**REMARKS**

This application has been carefully reviewed in light of the Office Action mailed March 23, 2004. Claim 13 has been amended. Applicants respectfully request reconsideration and favorable action in this case.

FIG. 4

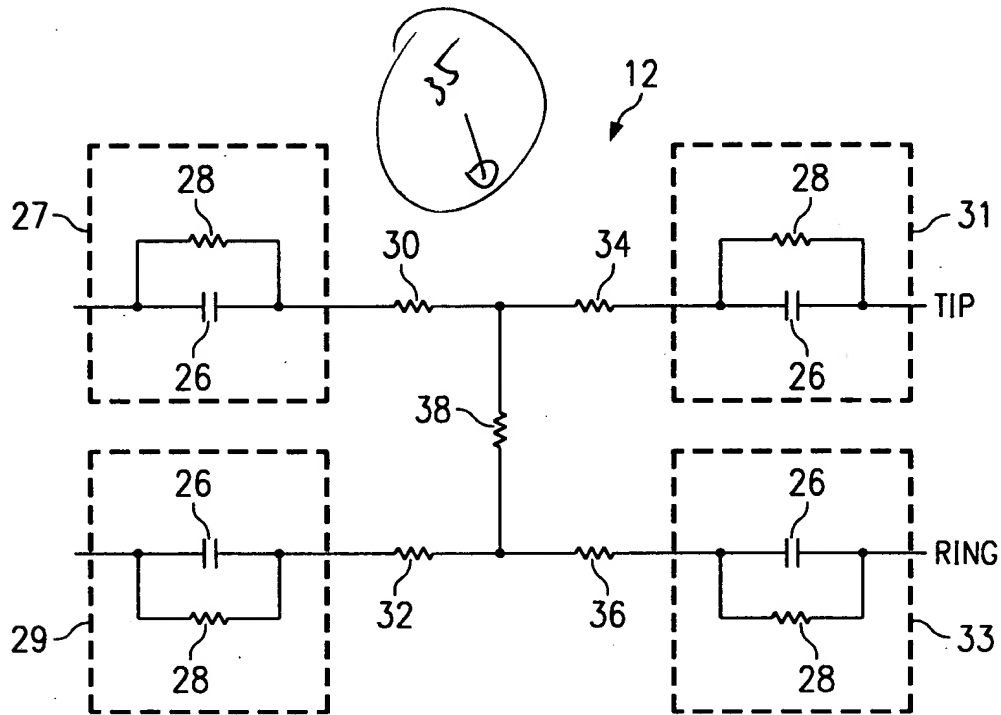
The Office Action objects to the drawings because FIGURE 4 does not show a reference number referring to “resistive section 35,” as described on page 24, lines 13-29 of the present specification. Applicants correct FIGURE 4 to provide a reference number “35.” In view of this correction, Applicants respectfully request the Examiner to withdraw the objection to the drawings.

Claim 9 is rejected under 35 U.S.C. § 112, first paragraph, as failing to comply with the enablement requirement. The Office Action states that the limitations of Claim 9 do not claim the same structure as the one described on page 20, lines 15-29 of the specification or shown in FIGURE 4, because, states the Office Action, “there are no sets of resistors in parallel with each other [in FIGURE 4].” Applicants respectfully disagree because the specification in fact does include an enabling description of the invention of Claim 9. For example, as shown in FIGURE 4, resistive element 30 is coupled in parallel to resistive element 32. Resistive element 34 is coupled in series to resistive element 30. Resistive element 36 is coupled in parallel to resistive element 34 and also coupled in series to resistive element 32. Resistive element 38 is coupled in series between the pair of resistive elements 30 and 34 and the pair of resistive elements 32 and 36. FIGURE 4 is also explicitly described on page 25, lines 19-29 of the Detailed Description section. Even if this were not the case, because Claim 9 is part of the original specification, it also provides enabling support. Thus, Claim 9 is fully enabled by the specification, and Applicants respectfully
